RECEIPT DATE: 3/4/19**ONSITE SEWAGE DISPOSAL SYSTEM**P 564773APPROVAL DATE: 3/18/19 SEC**PERMIT: CONSTRUCTION**

PROPERTY ADDRESS: 15208 Torino WaySUBDIVISION: Fairlane FarmsLOT: 29

**MEMORANDUM**

**RE: 15208 Torino Way**  
**Fairlane Farms, Lot 29**

FISHER, COLLINS & CARTER, INC.  
CIVIL ENGINEERING CONSULTANTS & LAND SURVEYORS  
CENTENNIAL SQUARE OFFICE PARK - 10272 BALTIMORE NATIONAL PIKE  
ELLICOTT CITY, MARYLAND 21042  
(410) 461 - 2855

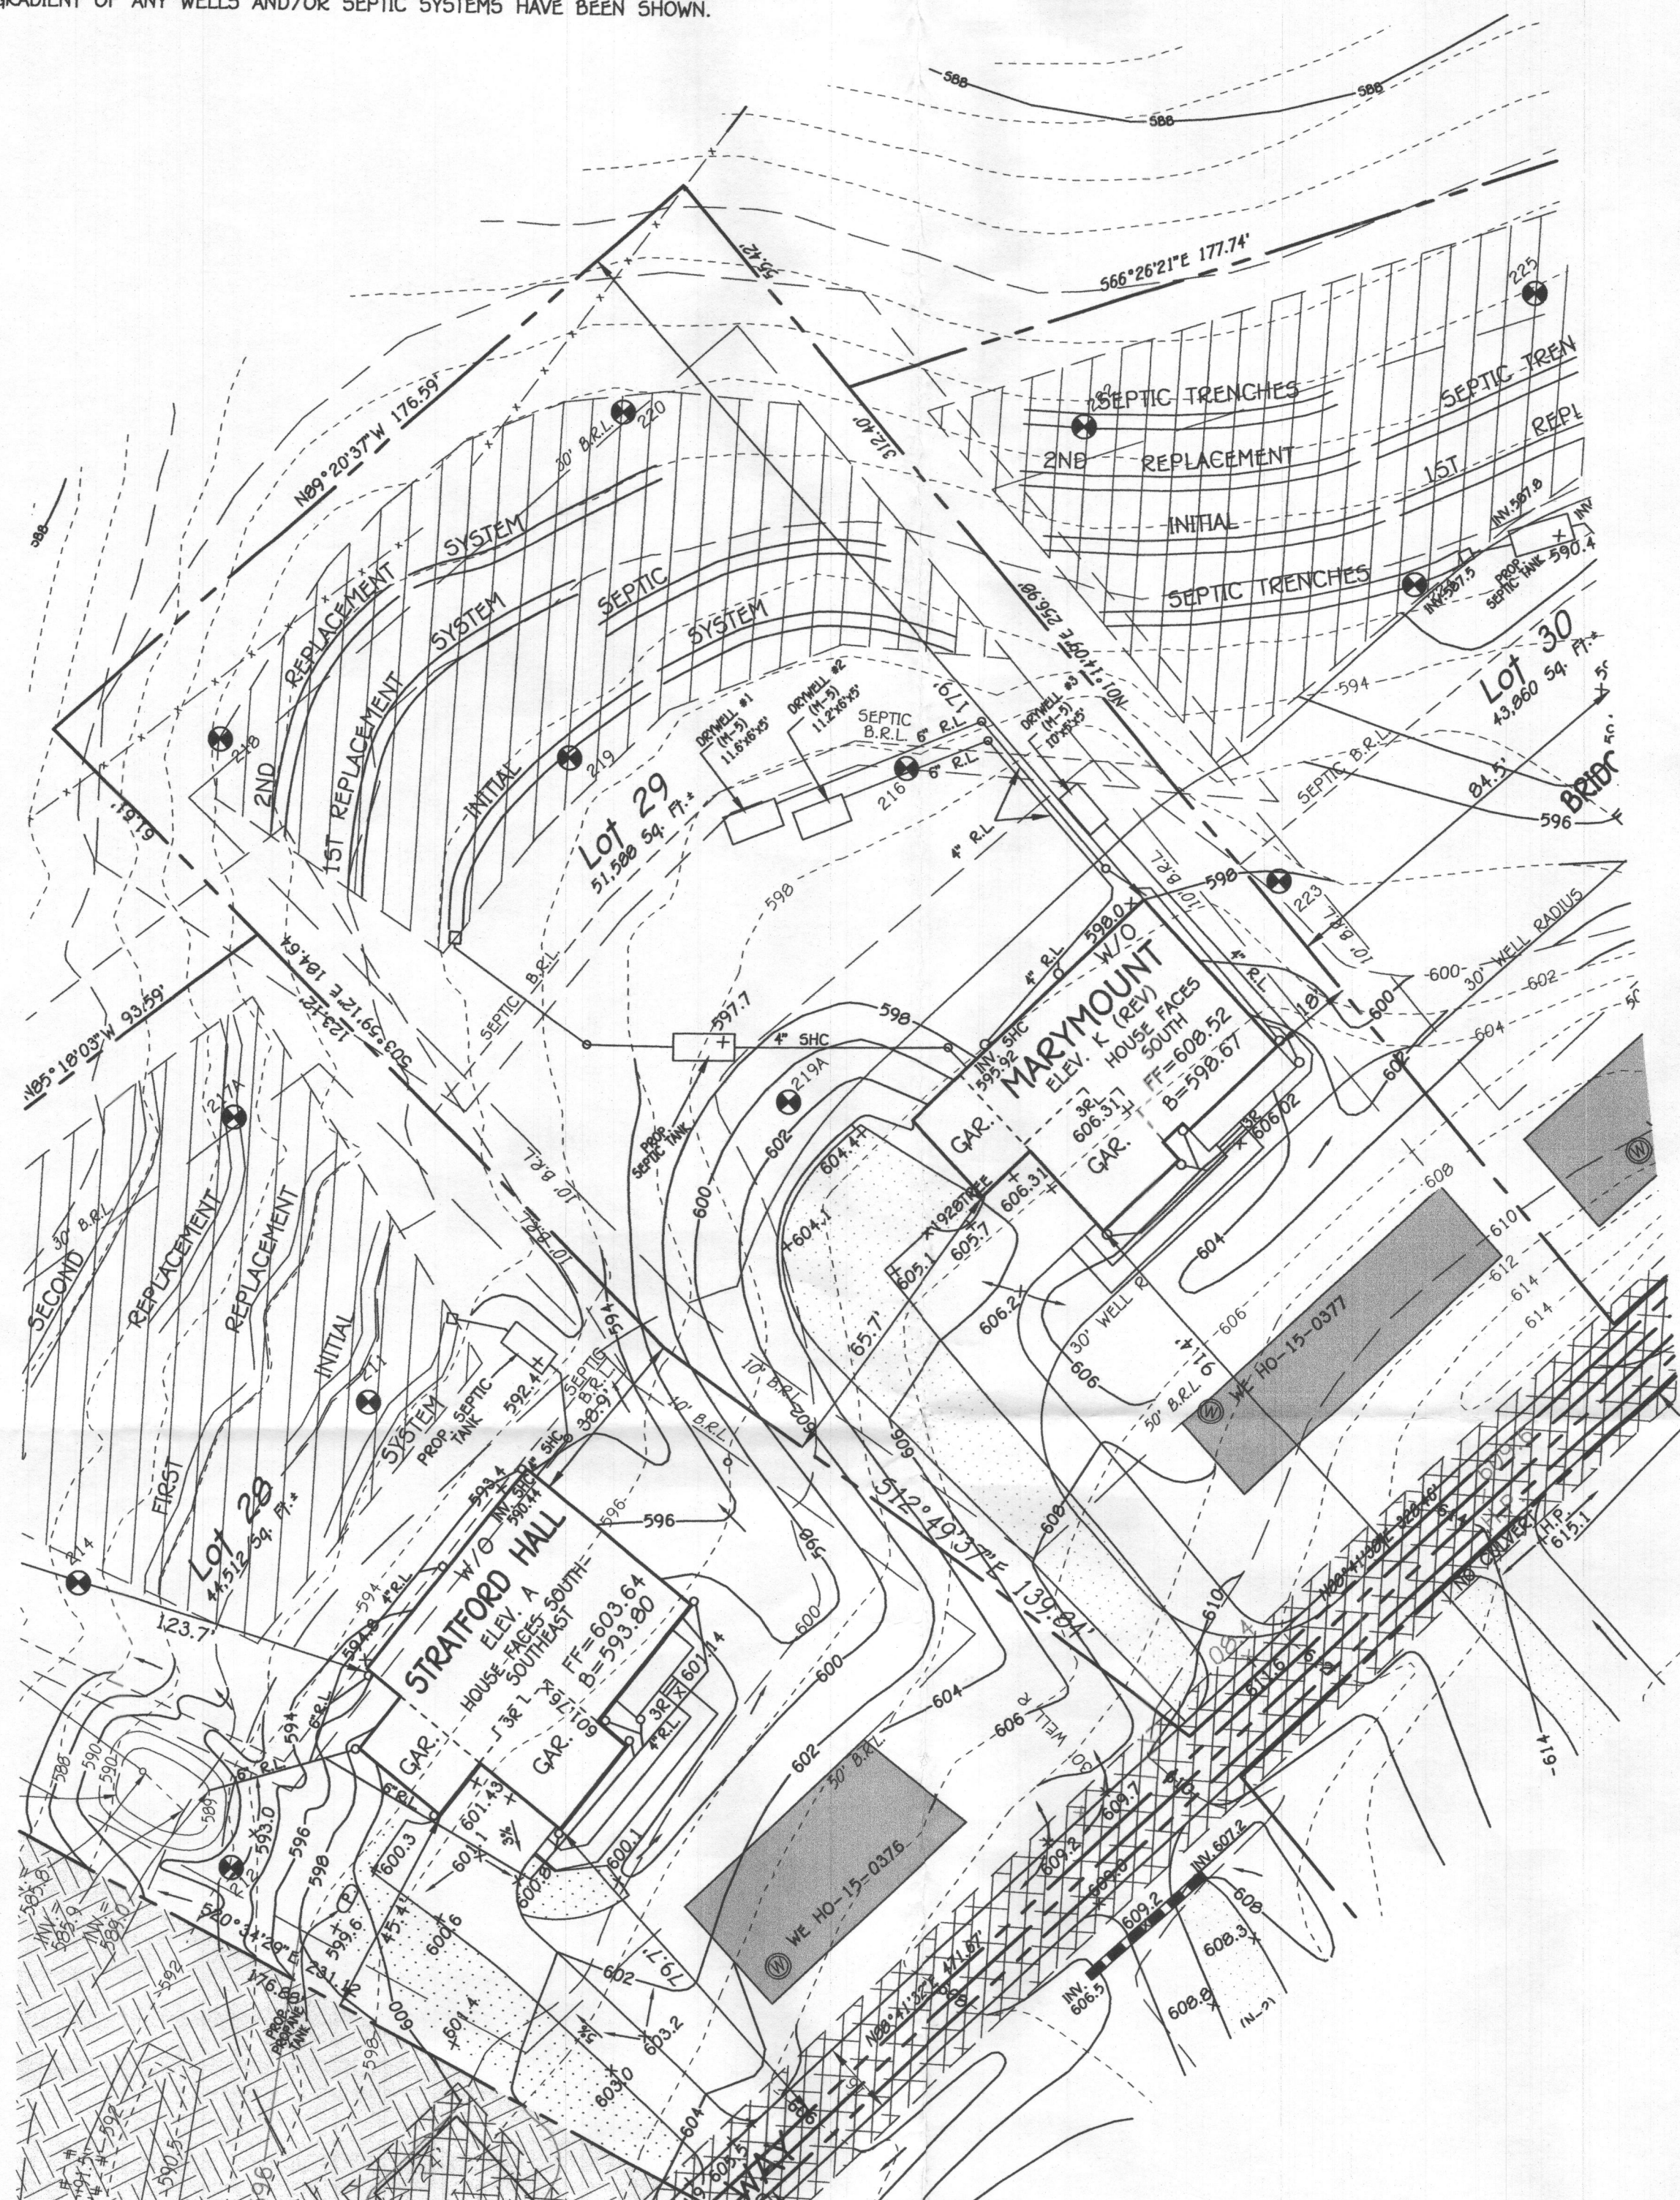
- 1.) Septic Profile doesn't match grading on plan and list of elevations. In addition, the length of pipe between 1<sup>st</sup> cleanout and tank in profile doesn't match length of pipe on plan.
- 2.) Raise d- box. The d-box may not be 5 feet in ground.
- 3.) Raise trench inverts to a minimum depth of 18 inches while maintaining at least 2% fall between tank and d- box.
- 4.) Initial trench reduction credit calculation should be 2 not 3 feet but 0.625 is correct.
- 5.) 1<sup>st</sup> replacement trench spacing calculation should be 11 feet (not 10).
- 6.) 2<sup>nd</sup> replacement reduction credit should be 0.55 (not 1.2). Trench spacing calculation, D = 2.5 (not 2) but 10 feet is correct.
